CITY OF SMYRNA

MEMORANDUM

RE: VARIANCE CASE V21-101
570 Disposal Plant Road – Allow reduction of the front setback from 35 feet to 12.5 feet.
VARIANCE CASE V21-102
570 Disposal Plant Road – Allow encroachment into the 75-foot impervious surface setback.

Figure – 2 Site Plan

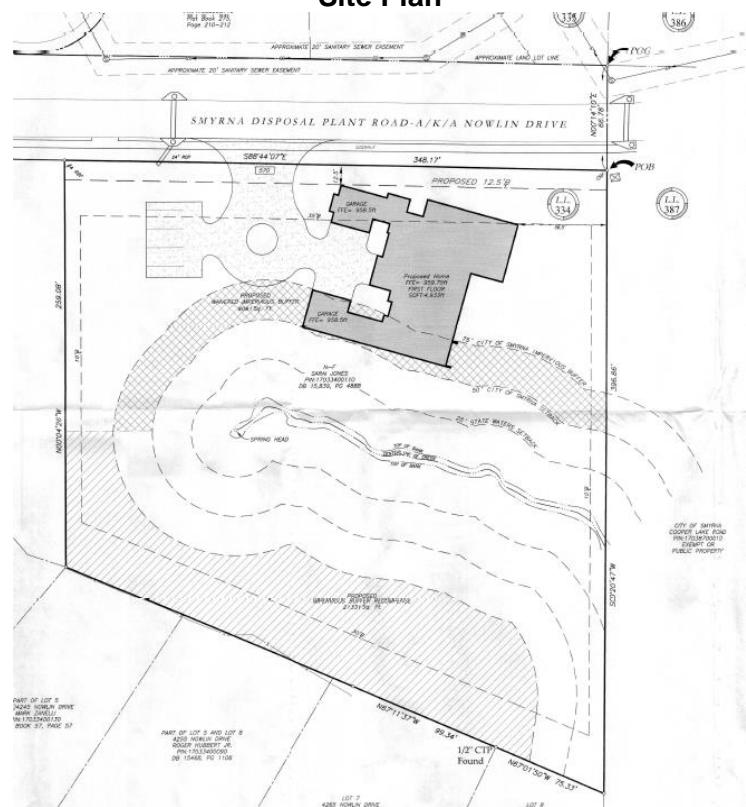
The applicant is proposing to build a 4,933 sq. ft. single-family home on the subject property. The applicant is requesting a front setback reduction from 35 feet to 12.5 feet for the preservation of the 50' Undisturbed Stream Buffer. Approximately 9,091 sq. ft. of impervious surface will encroach the 75' Impervious Surface Setback; however, the applicant will dedicate 21,000 sq. ft. of area elsewhere on the property for compensation. The site plan indicates there will be four guest parking spaces on the west side of the property. Community Development

recommends those spaces be removed to reduce impervious coverage for the site and lessen impact to the stream.

The City Engineer has reviewed the plan and can support the proposed buffer compensation. Prior to issuance of a land disturbance permit, the applicant will be required to submit a water quality plan for the site with 80% TSS removal.

1. Approval of the subject property for the requested variance shall be conditioned upon the development of the property in substantial compliance with the site plan and elevations submitted with the variance application.
2. The four guest parking spaces be removed from the site plan.
3. The applicant shall provide water quality for the site subject to approval by the City Engineer.
